Fan Product Change Notification

Change Notification #: PCN080323

Date of Publication: August 3rd 2023

This change affects ONLY the **09238RA series.** What has changed is that the position of the spokes were changed to standardize the casing shape and improve its rigidity.

09238RA (0 Type)

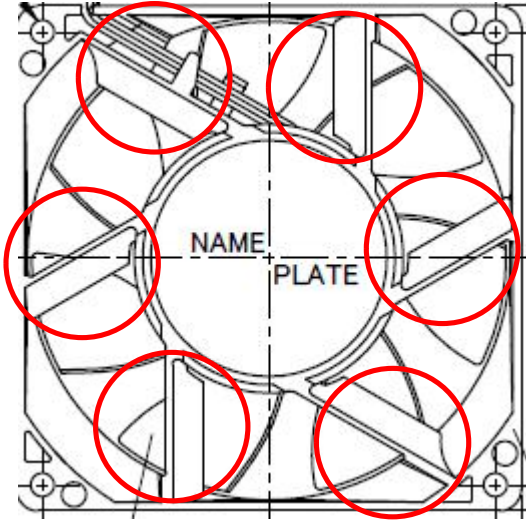
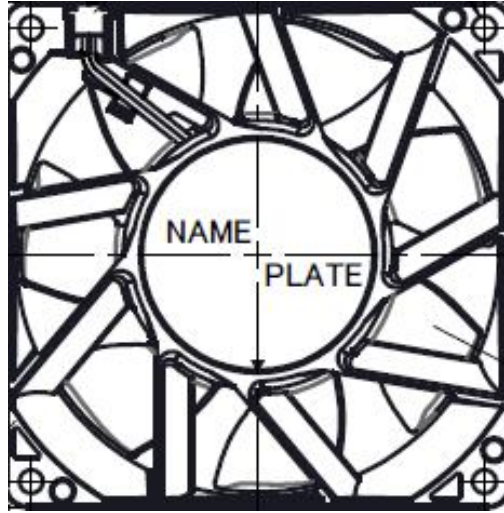
Number of spokes was increased from six (0 Type) to nine (D type) to standardize the casing shape and improve rigidity.

- Increase in spokes improves rigidity of the frame making it more durable and resistant to shock and vibrate
- Does not compromise form, fit and function
- Cost does not change from 0 Type to D Type
